Model: Aegis-P1 LCIT 5020(SCANDINAVIA)		Date: 27-Oct-08	No.: MD355001
Modified Article: Grip:End Fence		Prepared by: N.iida	
From: PPBG QA/Service Planning Dept.			
Reason for Modification:	☒ Parts catalog correction ☐ Vendor change ☐ Other ☐ To facilitate assembly ☐ To improve reliability ☐ To meet standards ☐ Part standardization ☐ Product Safety ()

Part Change Information List

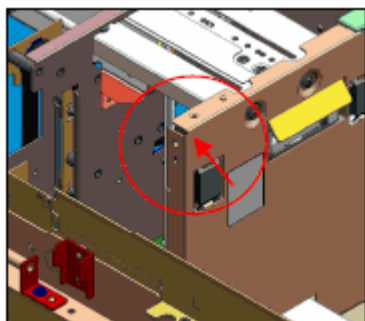
Change: The shape of this part was changed.

Reason: To further improve the part's durability.

Side fence cover after attachment:

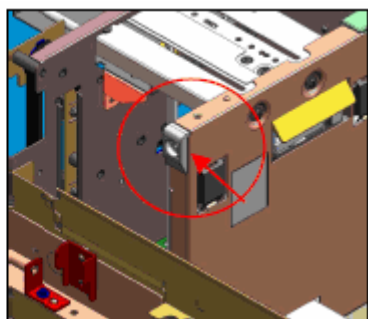
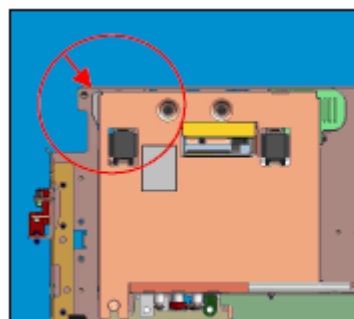
- 1) A cover for the side fence was added
- 2) The shape of the side fence was changed

Reason: To provide further protection when the paper is loaded into the tray.

NYLON CLAMP - 2N

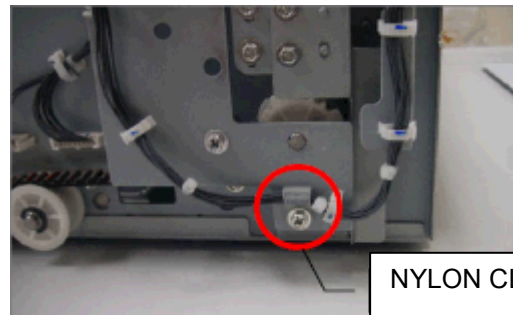
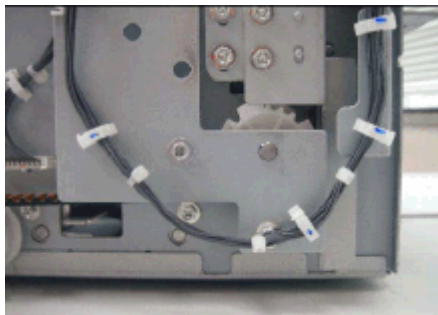
Nylon Clamp has been newly added due to the change made in the harness pathway. Please refer to RTB (RG178019a) for details in regards to SC622 (1st LCT Communication Error).

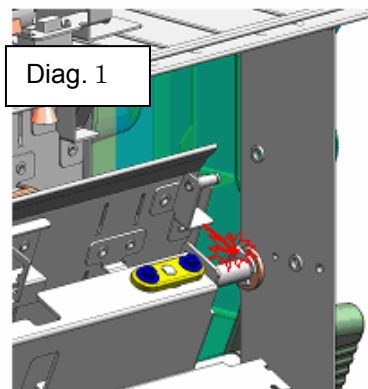
Change/Reason: The guide plate is damaged due to its interference with the Snap Ring as shown below (diagram 1). The fastening method has been changed by altering the Snap Ring to a Retaining Ring.

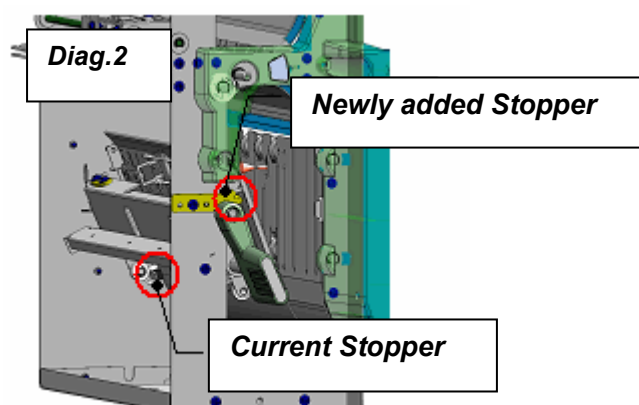
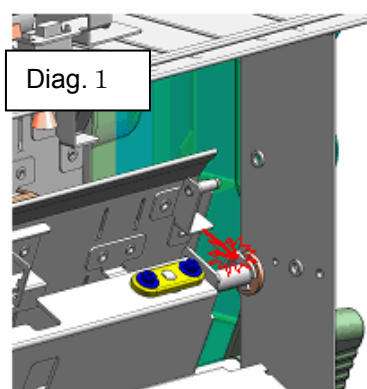
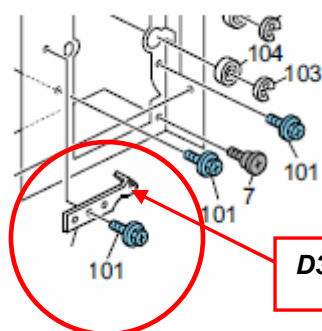
Change/Reason: The guide plate is damaged due to its interference with the Snap Ring as shown below in diagram 1. The fastening method has been changed by altering the Snap Ring to a Retaining Ring.

When opening the bottom guide plate, due to the absence of a stopper, the guide plate does not stop at its home position and is unstable.

To allow the guide plate to stop at its home position, STOPPER: FRAME has been newly added.

D3553885: STOPPER:FRAME

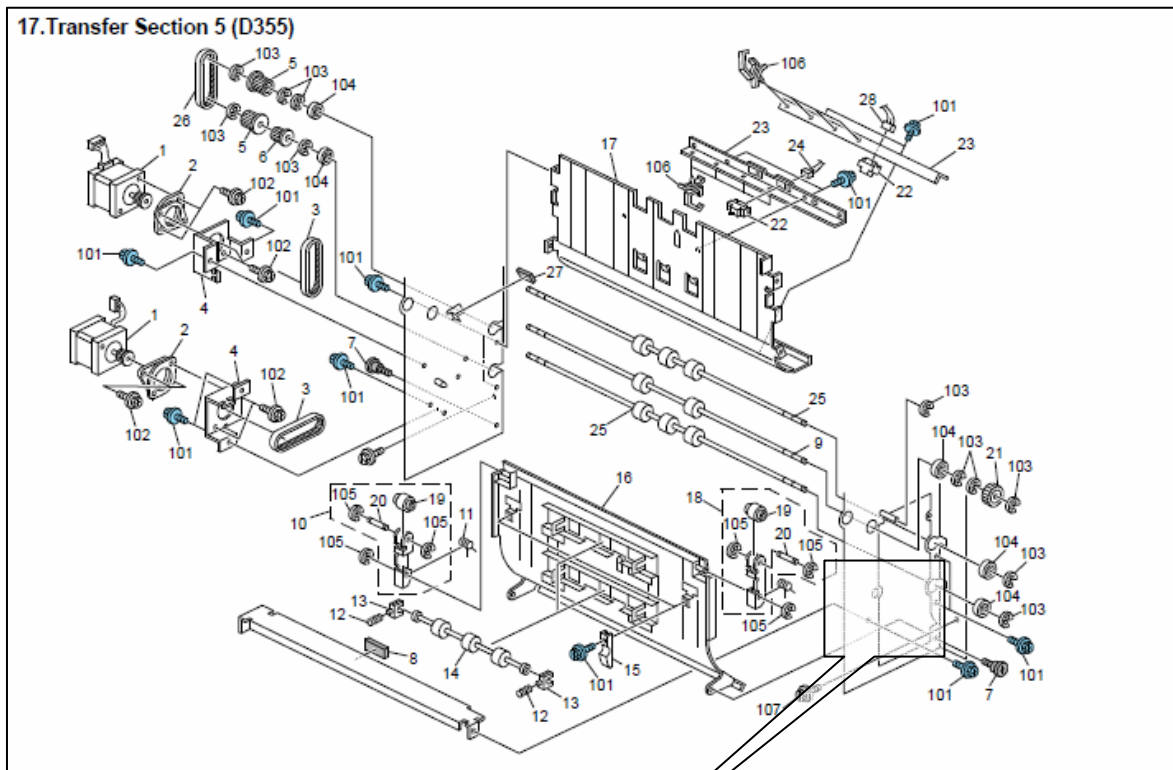
Please refer to the following page for its attachment position in the parts catalog.

6.Paper Tray 4 (D355)

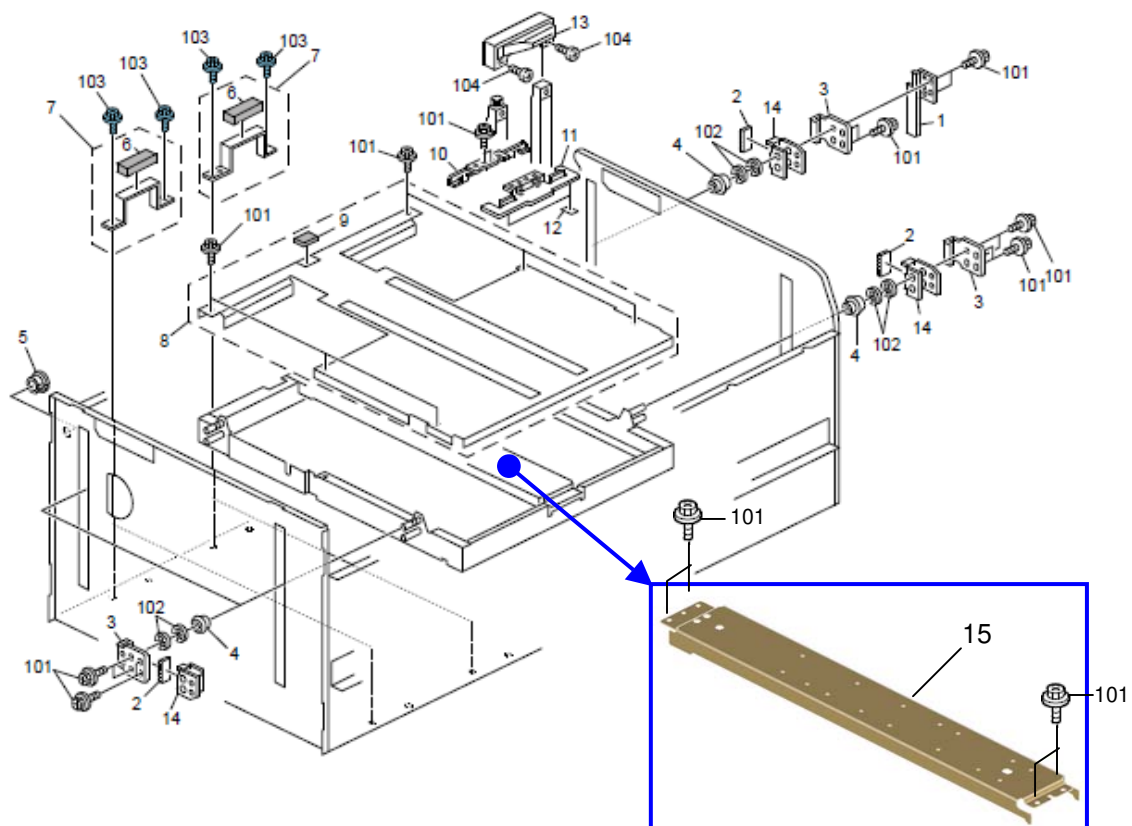
There was a case reported from the field of a bent paper tray stay.

The stay has been registered as a service part.
